## MT. NANSEN MINE

**REPORT  
ON  
1989 SITE INSPECTION  
OF  
MT. NANSEN MINE AREA**

Prepared for:  
**NORTHERN AFFAIRS PROGRAM**  
Whitehorse, Y.T.

Prepared by:  
**GEO-ENGINEERING (M.S.T.) LTD.**  
Calgary, Alberta

1. S
  2. C
- LOCATION OF BOREHOLES AND DAM OUTLINES**

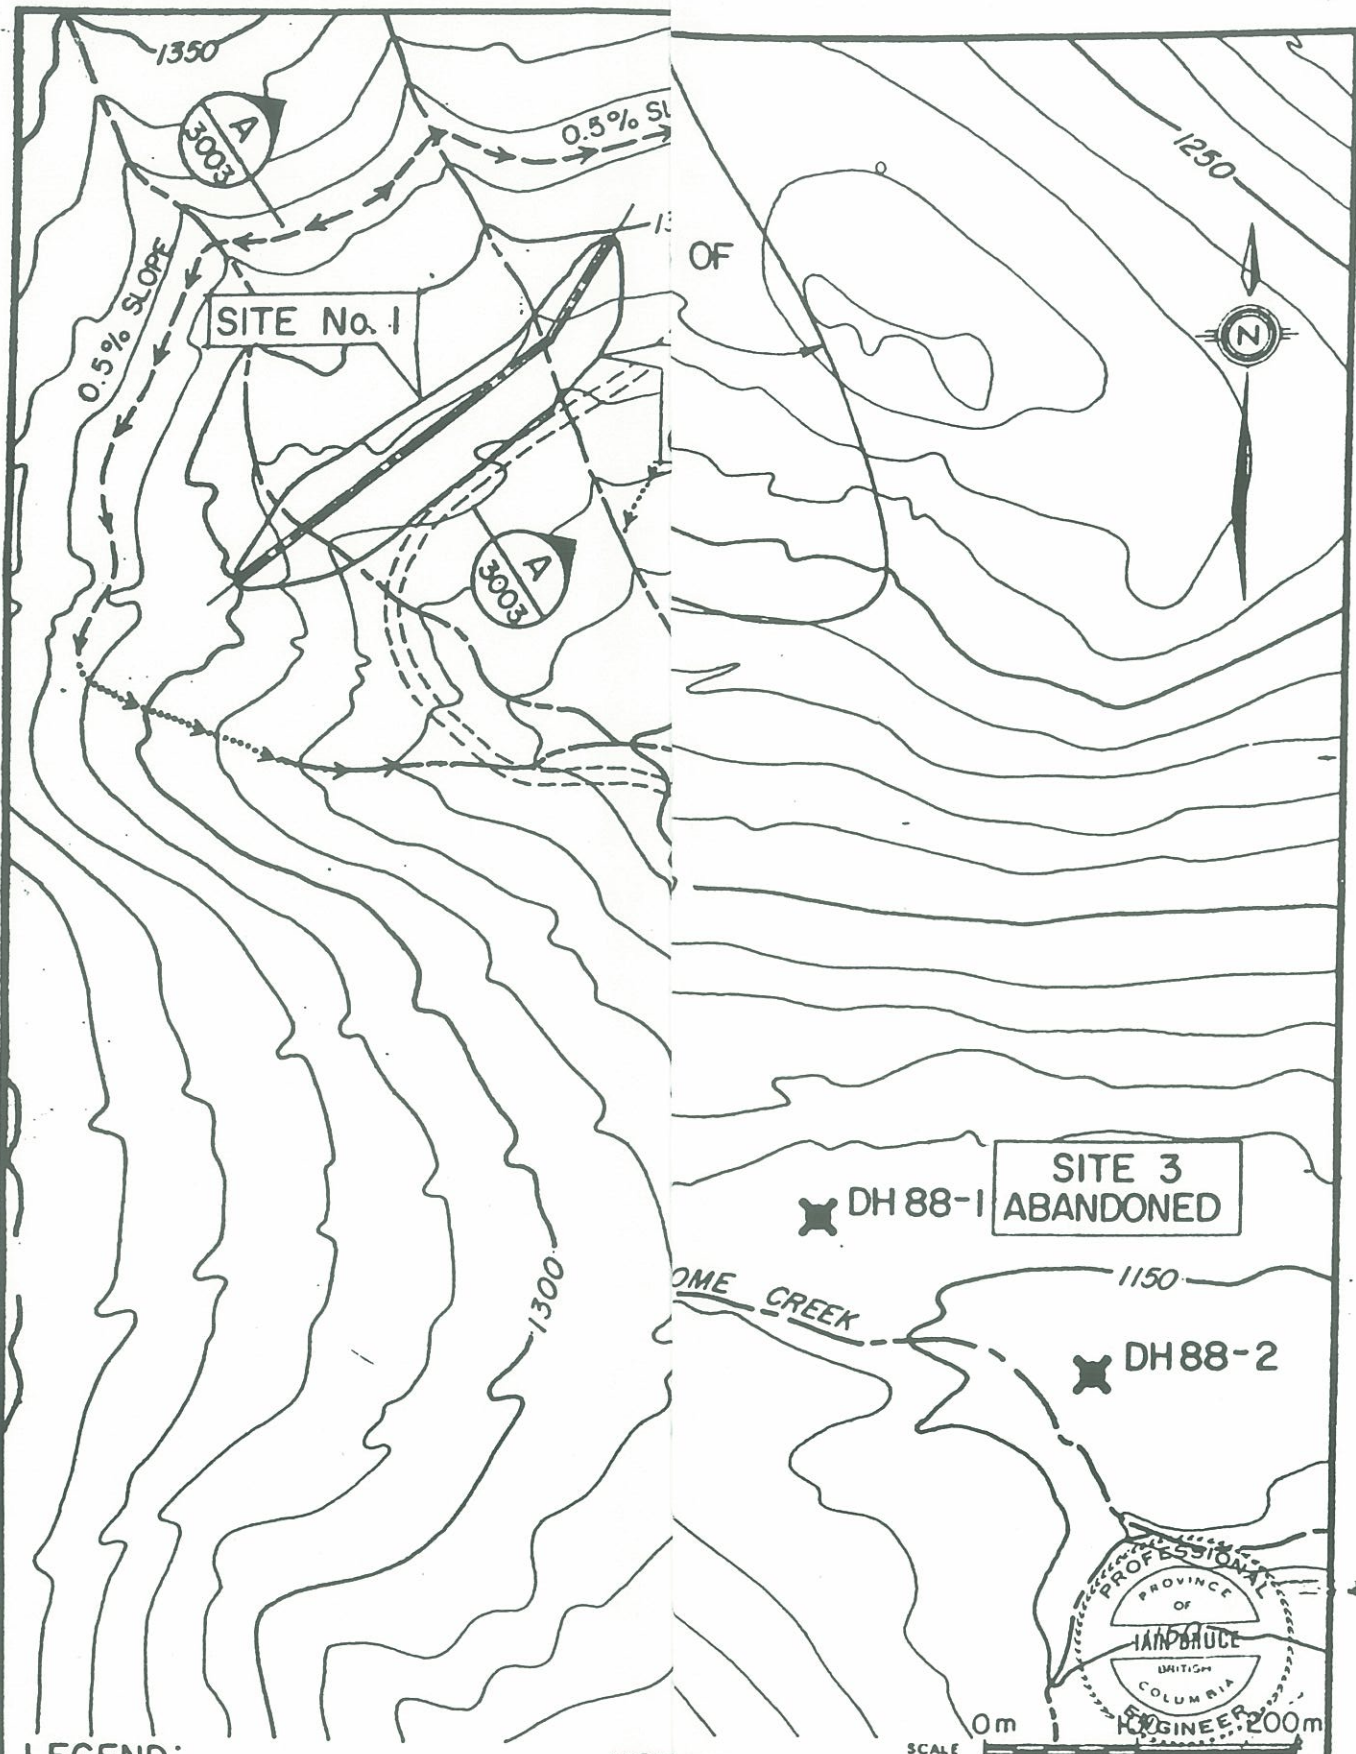
The designated area is approximately 150 m x 250 m in size and has been previously cleared. There are two minor intermittent drainage courses directing surface runoff into the proposed pond area (Figure 1).

Our review of geotechnical conditions indicate that neither of the proposed sites is entirely suitable for a permanent storing of tailings expected to be produced by the mine.

Site 1 is located in an area which should not experience significant ground deformations (because of apparent absence of segregated ice in the foundation). However, it is located in the head of the valley where it would obstruct natural drainage. Without maintenance, this obstruction would be eroded and the pond eventually destroyed. In addition, consideration should be given to the seepage from the pond since the fracture permeability of the subgrade could be quite high.

Site 2 is believed to be unsuitable for the proposed tailings pond. The considered pre-thawing of the ground prior to construction is believed to be unrealistic. In general, this concept has not received wide acceptance, due mostly to time and cost constraints.

We are in agreement with the conclusion of the Klohn Leonoff study regarding the better suitability of Site 1 (than Site 2) for the required tailings pond. The feasibility of Site 1 is, in our opinion, not well established.

It is recommended to re-consider the proposed tailings pond locations. Since the objective is to locate the facility in an area where it could remain indefinitely, consideration should be given to a site which would meet this objective.

It is our opinion that the proposed diversions of existing drainage courses around the pond area cannot be permanent without periodic maintenance.
